FIRE REVIEW

PROJECT INFORMATION:
JB HENDERSON FABRICATION FACILITY
TRUMBULL AVE., SE & CONCHAS STREET, SE
ALBUQUERQUE, NM 87123

SHEET NAME & NO.
FIRE 1
SITE PLAN
FIRE 1

AI SITE PLAN - FIRE 1
SCALE: 1" = 20'

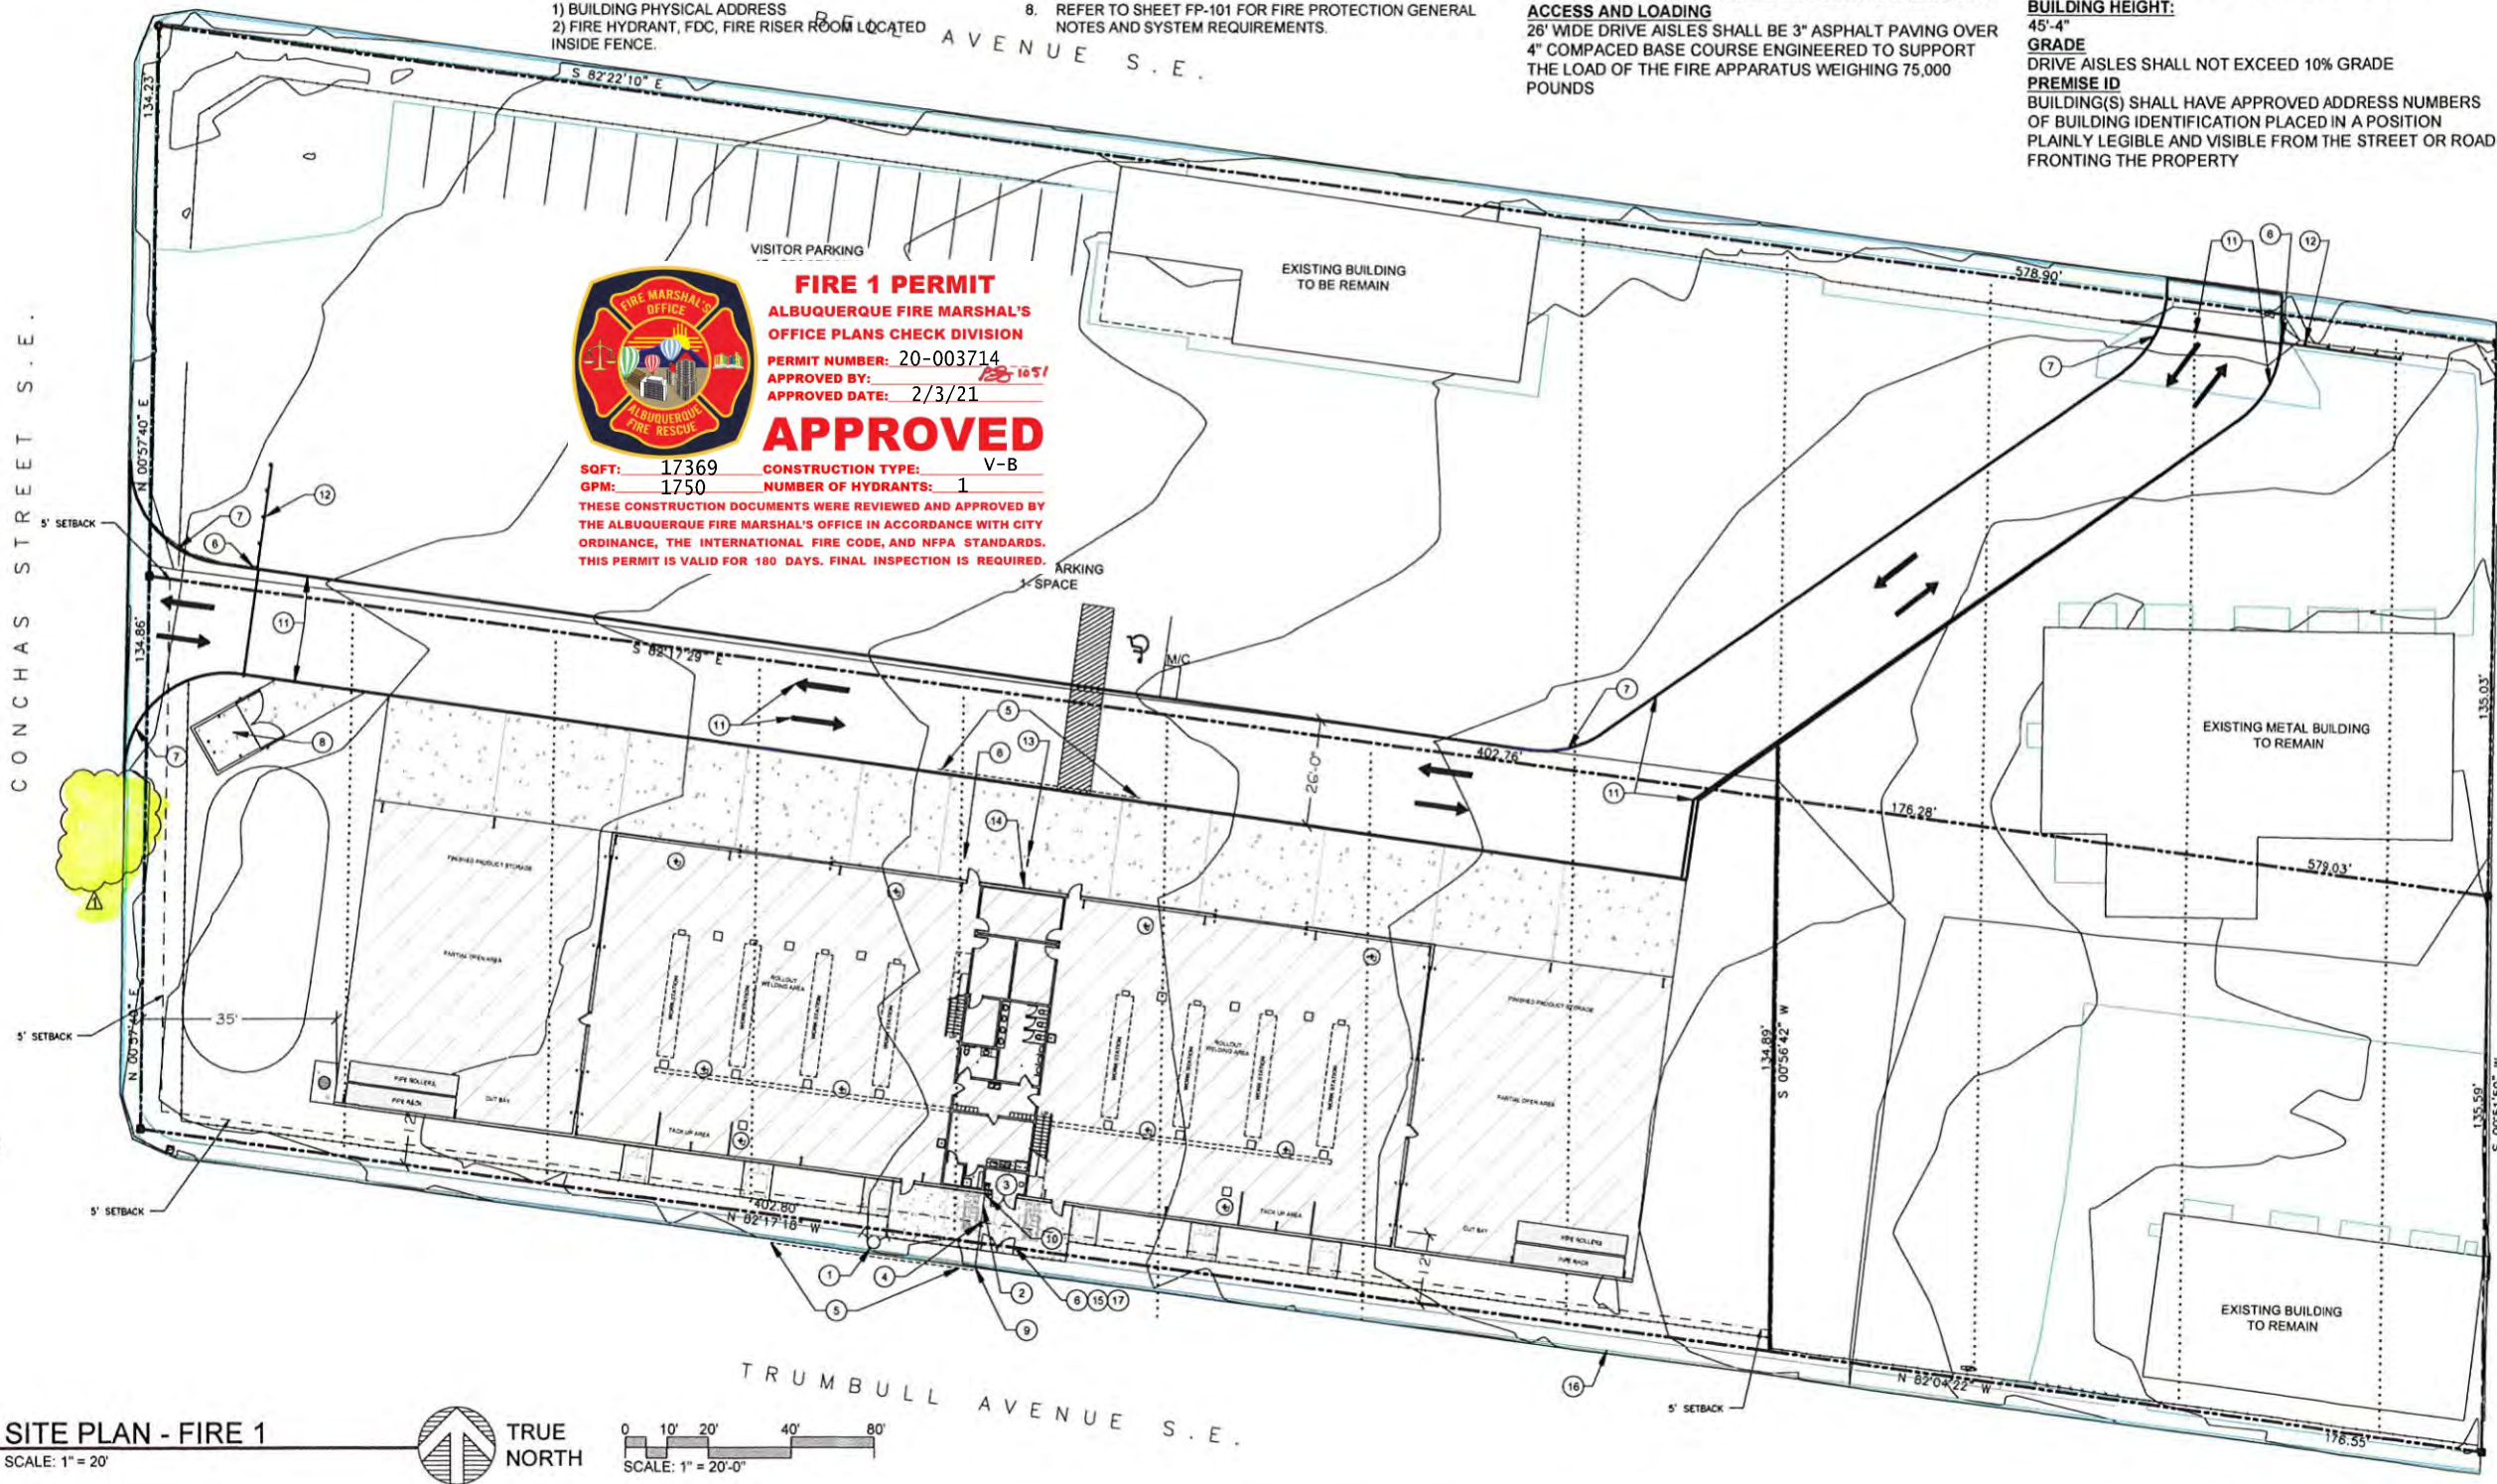
No.	Date	Remarks	By
1	2/3/21	DELETE WEST FIRE HYDRANT	LRO
